Planning Commission
Council Chambers
February 15, 2022 – 6:00 p.m.
233 South Main Street, Monroe, Ohio

CITY OF MONROE
Inter-Office Correspondence

DATE: February 15, 2022
RE: Information Packet for February 15, 2022 Planning Commission Meeting at 6:00 p.m.

I. Case No. 2022-2-3— Consideration of Site Plan Application for Brooks 63 Retail Plaza

C-5.1

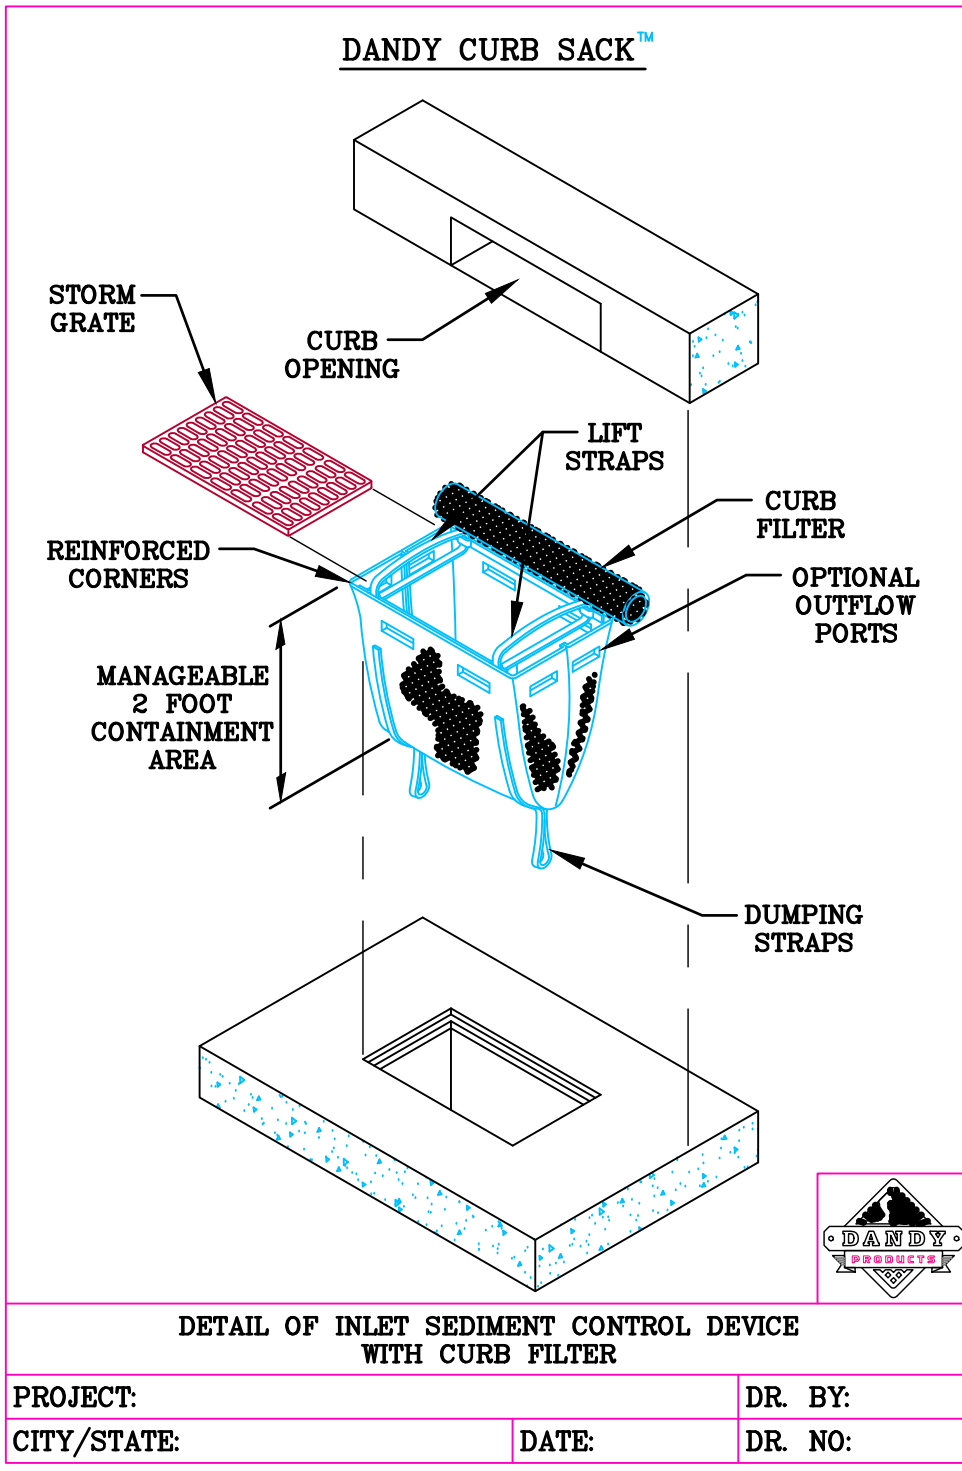
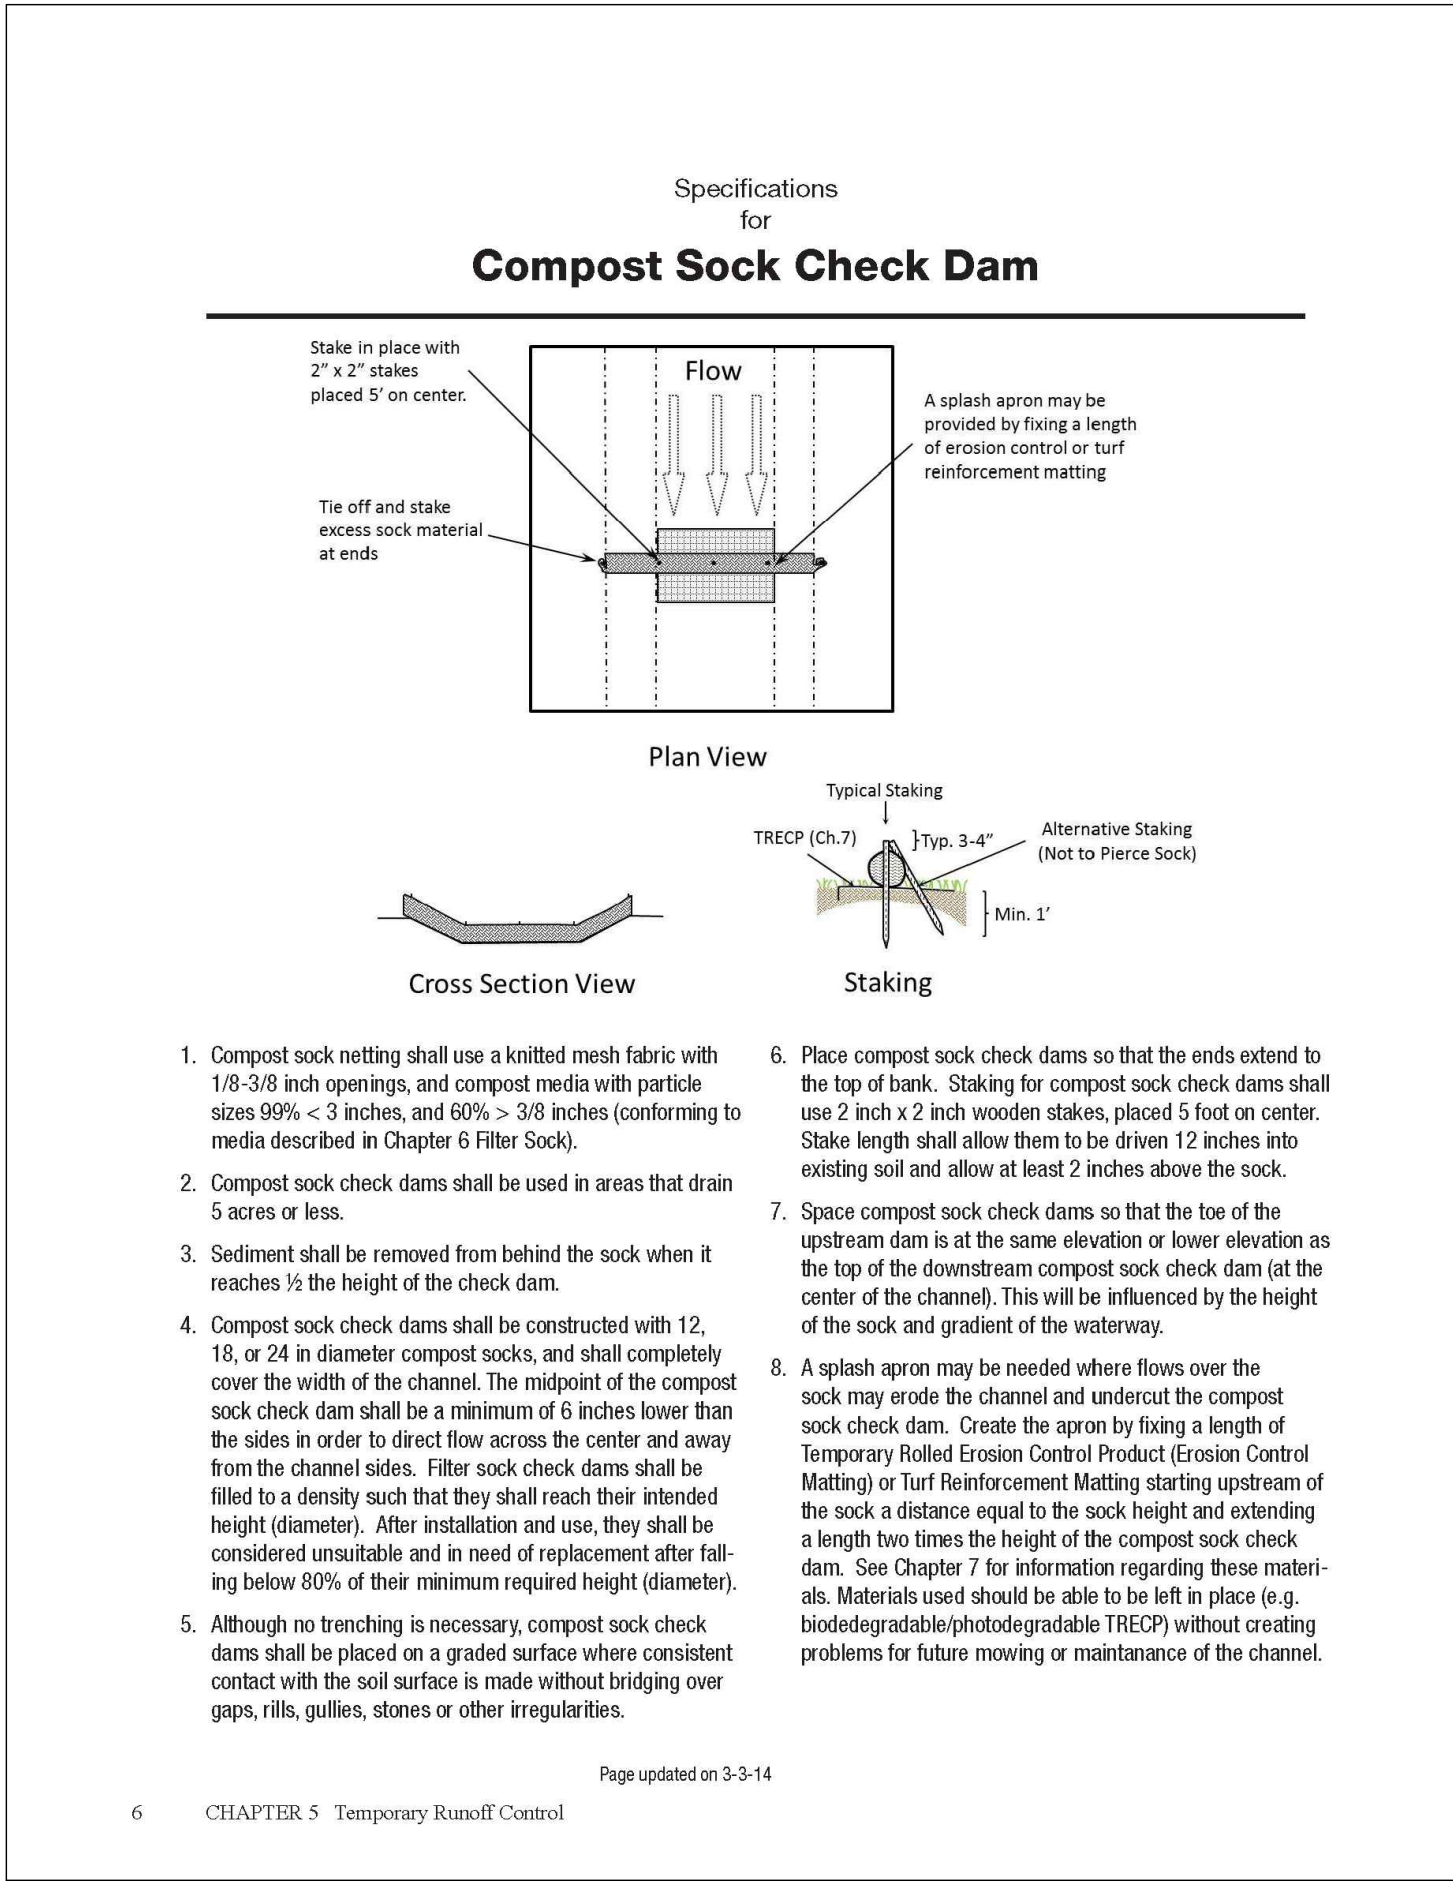
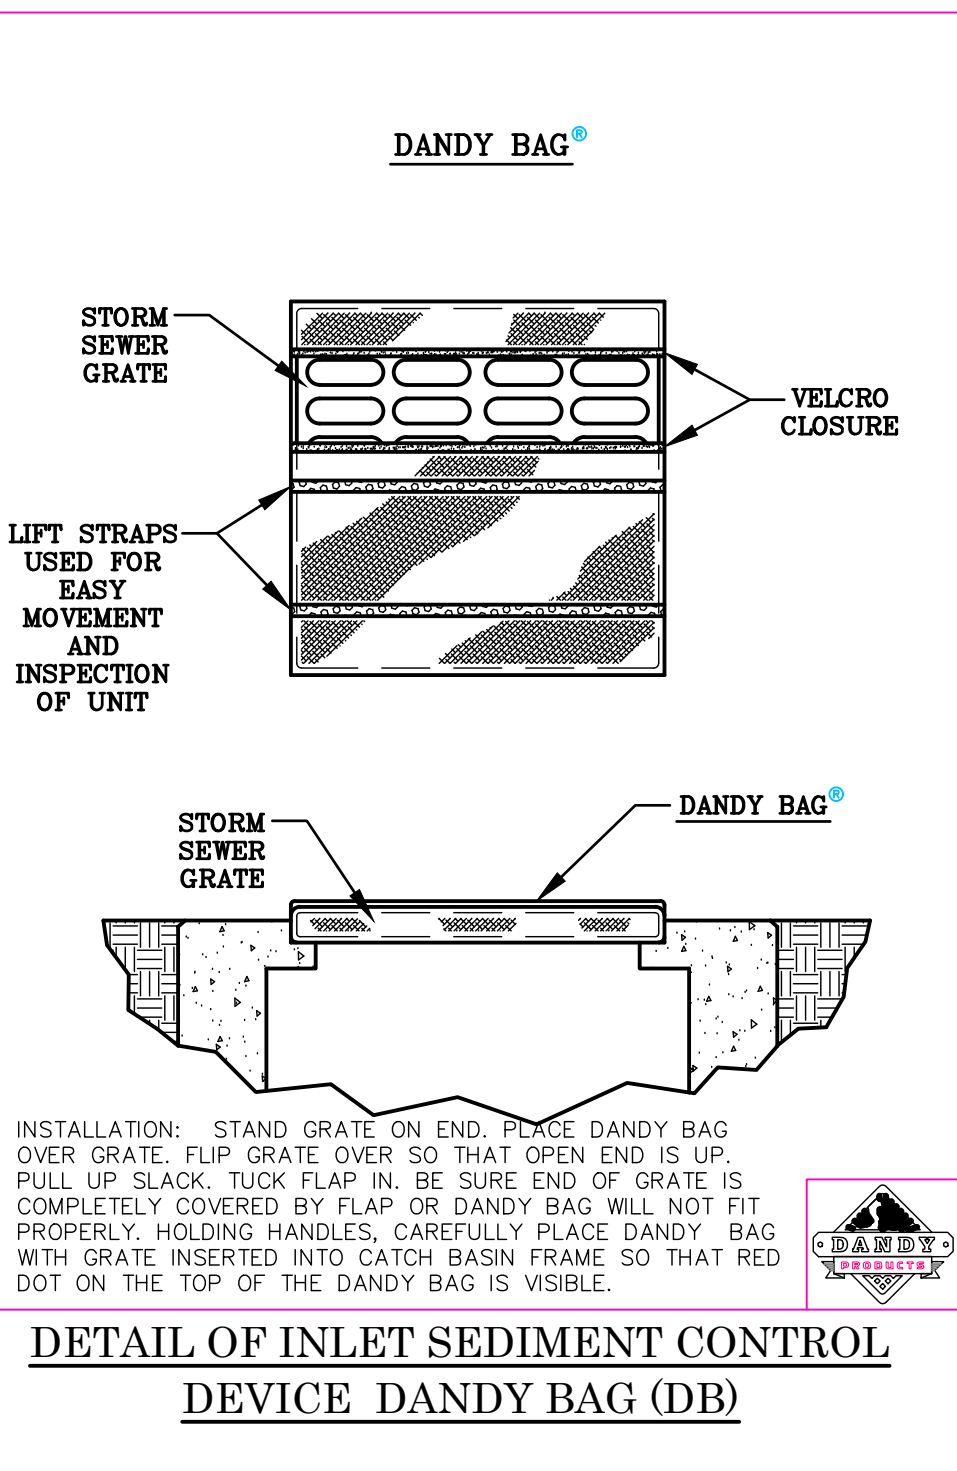
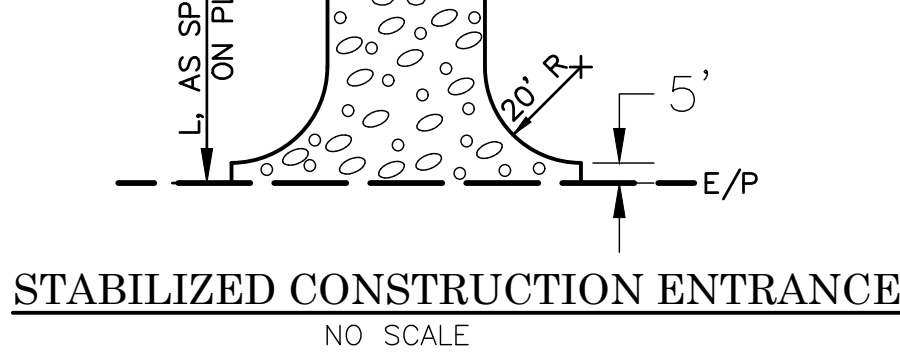
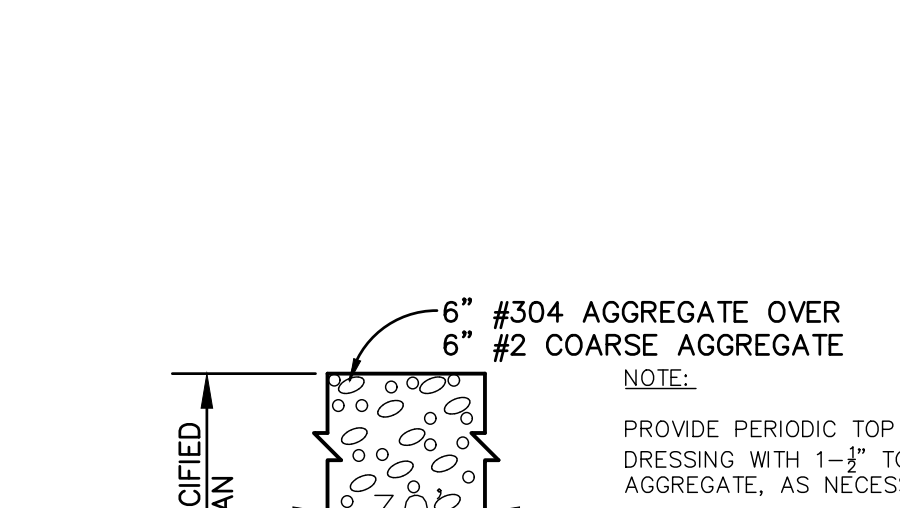
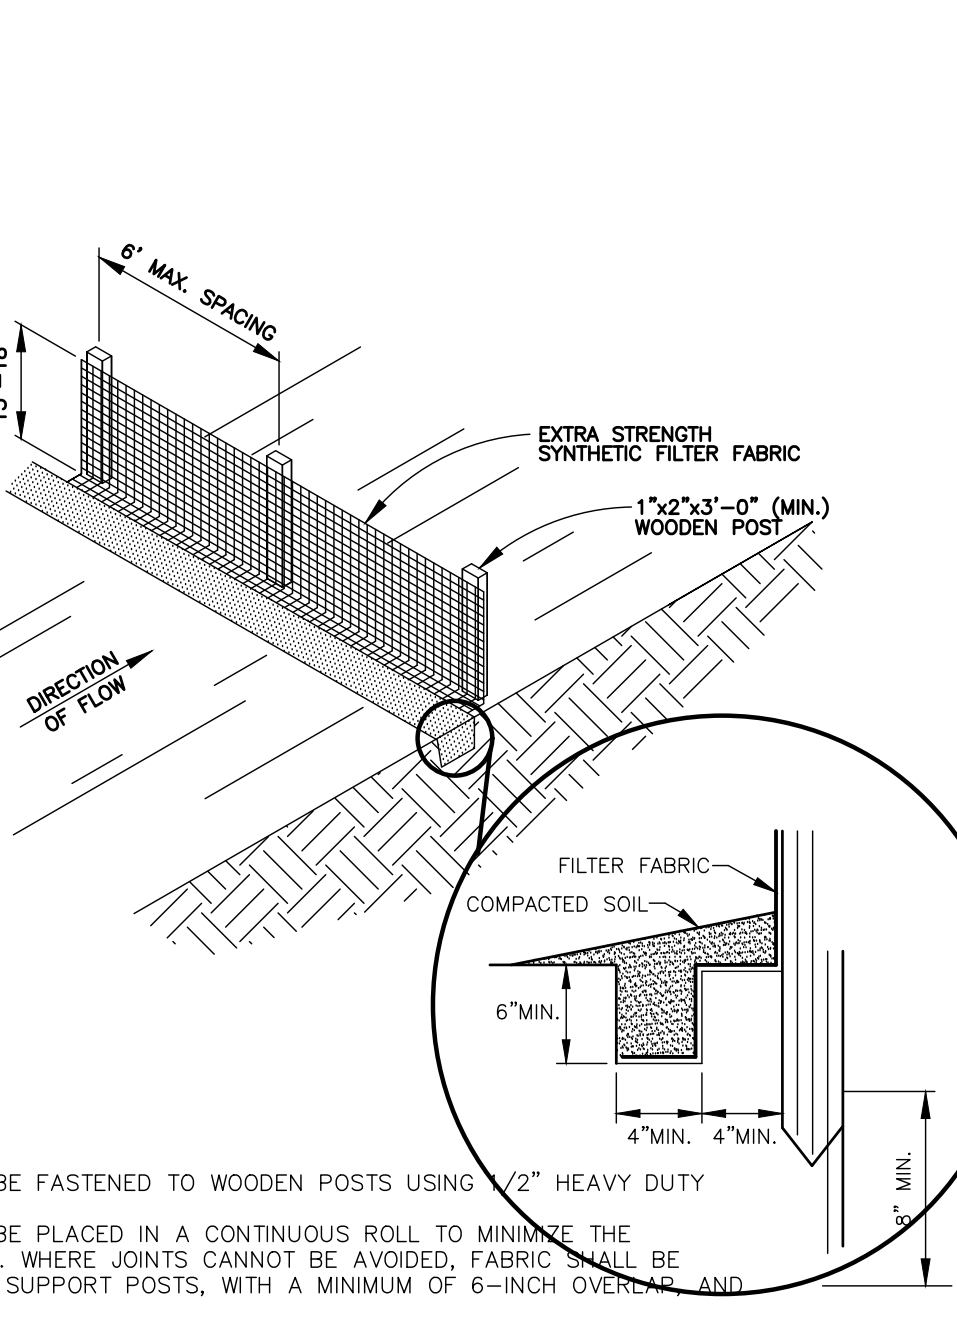
- **Fishbeck Comment No. 14** – On Sheet C-5.1, the “Compost Sock Check Dam” shown on this sheet does not appear on Sheet C-5. Delete this item from Sheet C-5.1.

- **Fishbeck Comment No. 15** – Provide a maintenance schedule for the Stormwater Best Management Practices during construction.
- **Fishbeck Comment No. 16** – On Sheet C-5.1, text in the Stormwater Pollution Prevention Plan is difficult to read. Consider making the sheet 2 pages so that text height and resolution can be improved or submit a separate report.

1
A2.1

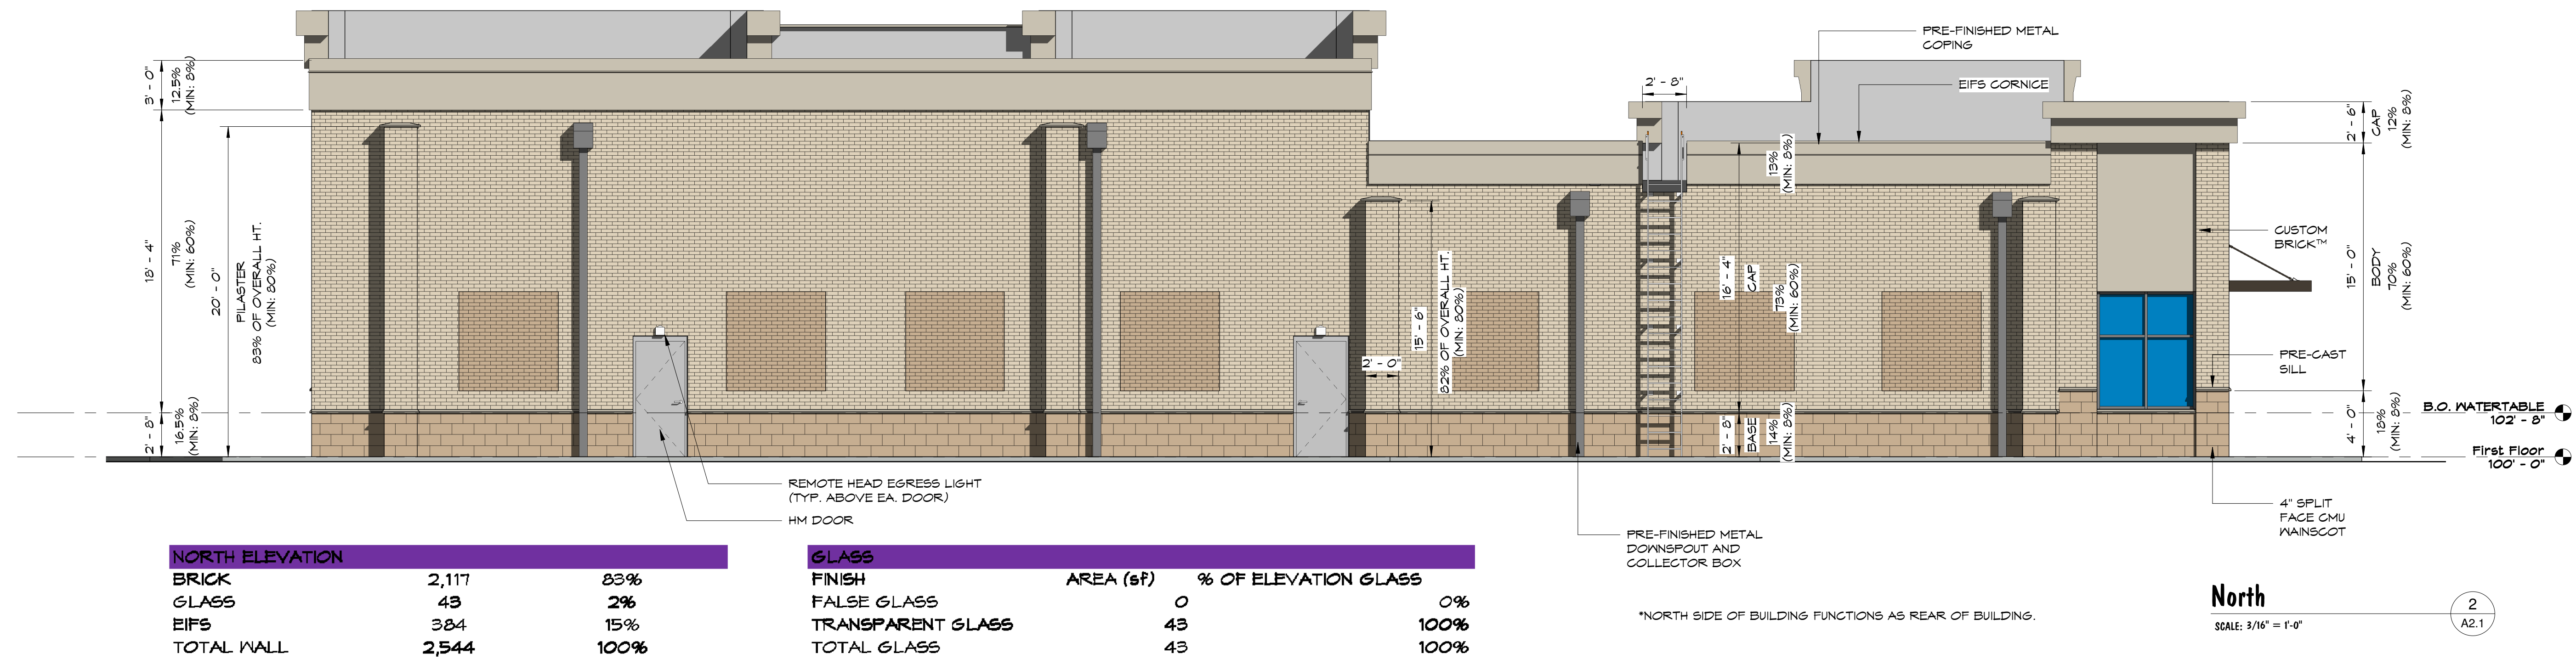
- Please provide further detail on the darker brick shown on the north side of the building. Staff would like clarification as to whether this is inset or brick detail work or just a different color brick.
- Please confirm the minimum building height. There appear to be a couple points along the building that may be at 19 FT rather than the 20 FT minimum required.
- Elevations visible from a right-of-way are required to contain at least 25% windows.

- The north side of the building does not meet this requirement.
- Staff acknowledges the north side of the building functions as the rear of the building. However, the requirement still applies given the large amount of visibility this side of the building has along Brooks Drive.
- As an alternative to functional clear windows, Staff suggests false windows, incorporation awnings, utilizing brick inset detail work, or glass doors.
